Item 3.**Development Application: 42-50 Parramatta Road, Forest Lodge - D/2020/1088**

File No.: D/2020/1088

Date of Submission:	27 October 2020
	Amended plans and documentation received on 22 January 2021
	Contamination information received on 4 May 2021
Applicant:	Health Infrastructure NSW
Architect/Designer:	Architectus
Owner:	Health Infrastructure NSW
Planning Consultant:	_planning Pty Ltd
Cost of Works:	\$15,247,348.00
Zoning:	B7 Business Park, the proposal includes an 'emergency services facility' and an envelope for the indicative land use as a 'commercial premises'. These uses are permissible with consent in the zone.
Proposal Summary:	<p>The application seeks consent for the concept approval of the staged construction of a two (2) storey emergency services facility (on the northern portion of the site, fronting Arundel Street) and a three (3) storey commercial building envelope (on the southern portion of the site, fronting Parramatta Road).</p> <p>The proposal also seeks consent for the detailed design of the Stage 1 works on the northern part of the site, which include the construction and use of the two storey building as an ambulance station (Central Sydney Ambulance

Figure 22: Ambulance Station - North-South Section, extent of envelope for Stage 2 works shown coloured red

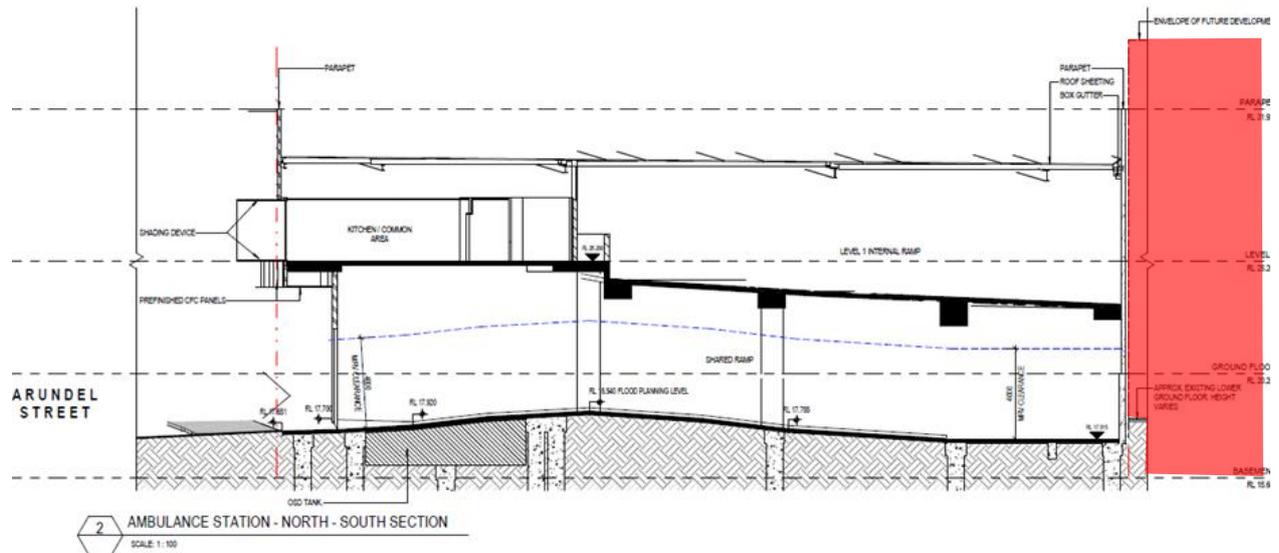
45. The submitted architectural plans identify that the Stage 1 works (ambulance station) are proposed to be built to the southern common property boundary shared with the proposed allotment for Stage 2 works. This is shown in the section plan provided at Figure 22.

46. The ambulance station does not include any openings or windows along this boundary and provides a blank facade to the Stage 2 southern allotment.
47. The detailed design of the ambulance station does not constrain the future development of the Stage 2 works. The Stage 2 works will comprise a commercial premises use and could be built boundary to boundary or could be set back off the shared boundary to include openings. The treatment of the northern facade of the future Stage 2 building would need to be considered as part of a future detailed design DA.

Figure 23: GFA plans showing the areas coloured beige, turquoise and light blue as constituting GFA

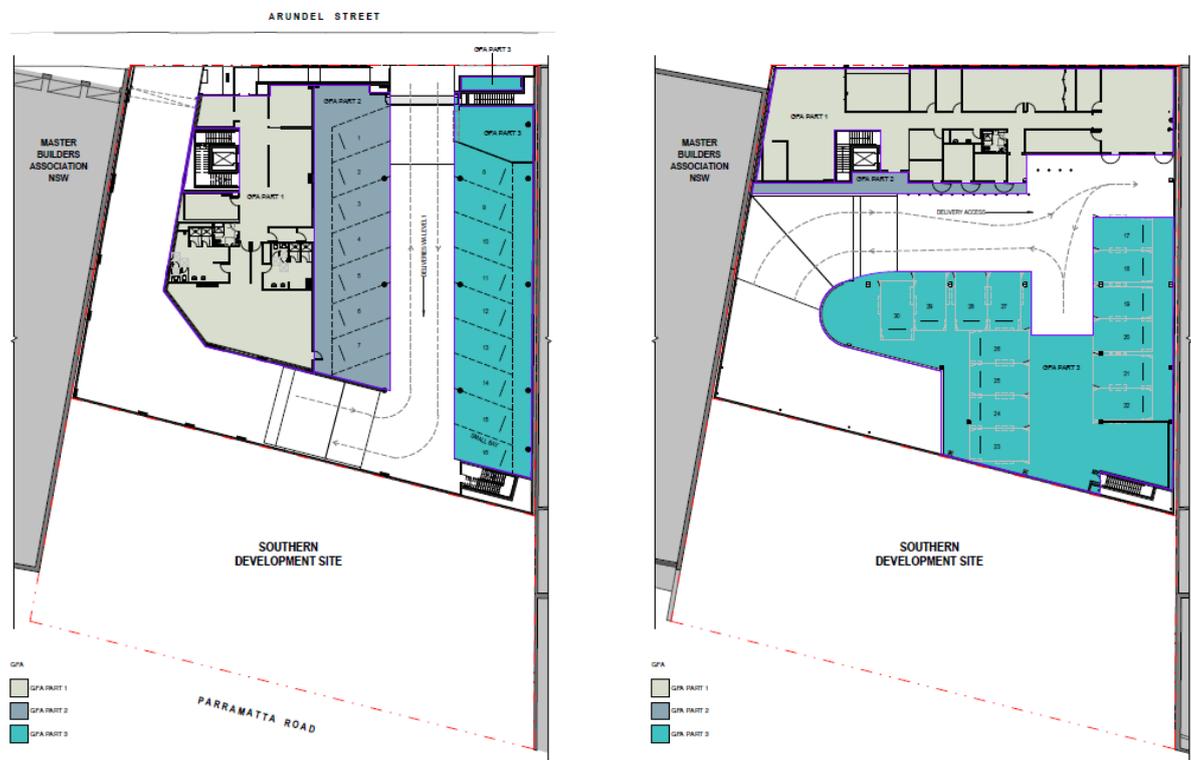
48. In accordance with the definition of GFA provided in the SLEP 2012, the applicant has included the following areas as GFA in relation to the Stage 1 works:
 - all functional areas of the ambulance station building including offices, storage rooms, lockers, amenities, kitchen, balcony, meeting rooms, areas for servicing and corridors;
 - the response ready zone at ground level which comprises parking for 16 ambulance vehicles; and
 - the make ready zone at first floor level which comprises parking for 14 ambulance vehicles.
49. The applicant has excluded the following areas as GFA in relation to the Stage 1 DA:
 - the basement level including the driveway access to the basement;
 - all areas comprising common vertical circulation including lifts and stairs within the ambulance station building; and

- the multi-purpose bay at first floor level and access to that bay which is provided from the ground floor entry at Arundel Street via a ramp to first floor level. The applicant has also excluded an area to allow vehicles to safely manoeuvre in and out of this bay.
50. The applicant has stated that the multi-purpose bay functions as a loading bay. In accordance with the definition of GFA in the SLEP 2012, any space used for the loading or unloading of goods (including access to it) can be excluded from the calculation of GFA.
51. The applicant's GFA diagrams are provided at Figure 23. Areas calculated as GFA are coloured beige, turquoise and light blue.
52. Council officers agree with the applicant's calculation of GFA for the Stage 1 works.

Figure 24: Ambulance station ground floor illustrating proposed access arrangements

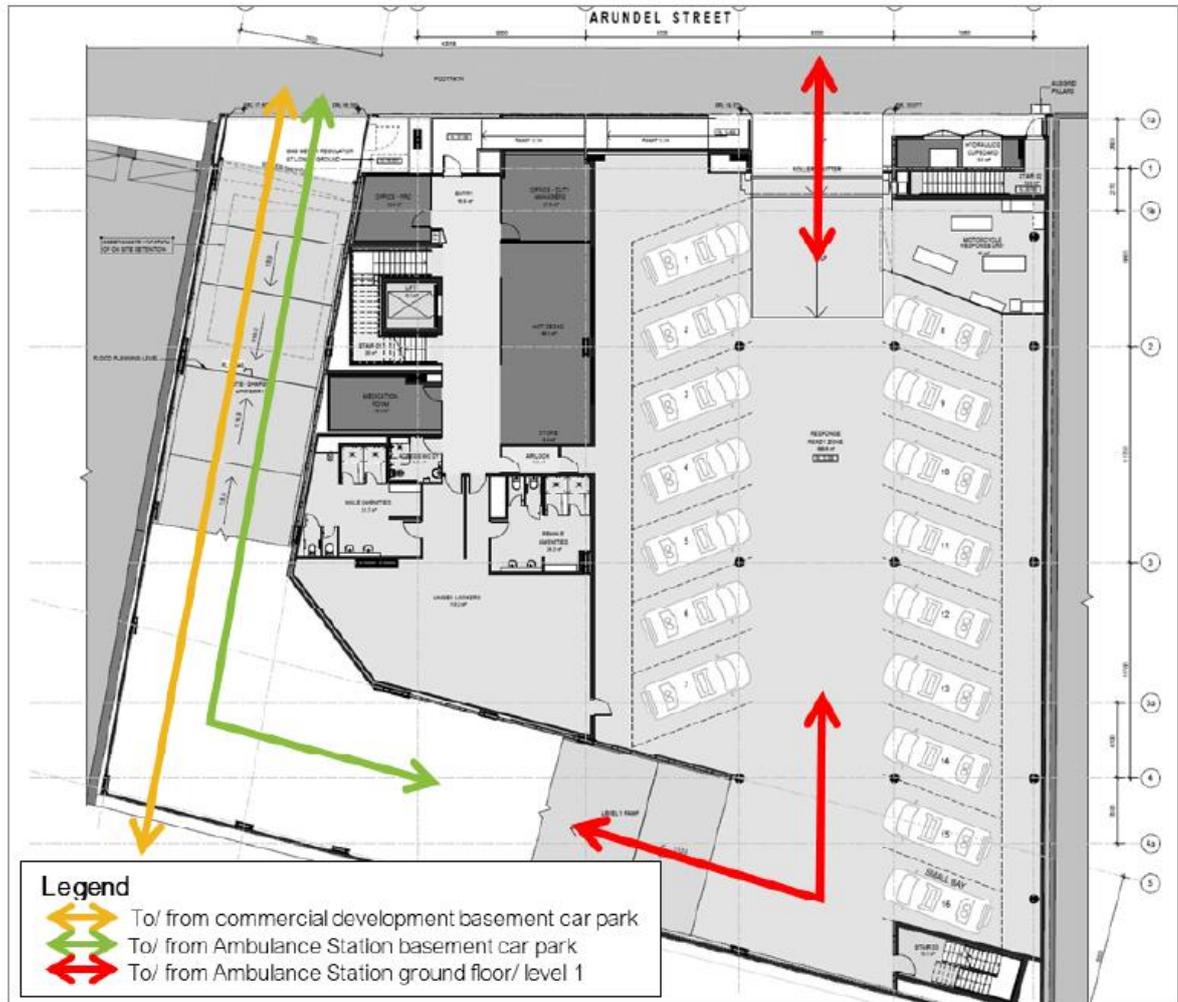
88. Access to the ambulance station is proposed from Arundel Street.
89. Access to the ambulance station's basement car parking is provided on the site's western extent, generally in the same location as the existing basement parking access within the former NSW Coroners Court building.
90. A separate access is provided for ambulance vehicles entering and exiting the site located on the site's eastern extent. Access will be provided via a new two-way driveway. The operational requirements of the proposed ambulance station necessitate a two-way driveway to be provided to enable ambulance vehicles to safely and quickly exit the site.
91. The site access arrangements are illustrated at Figure 24.
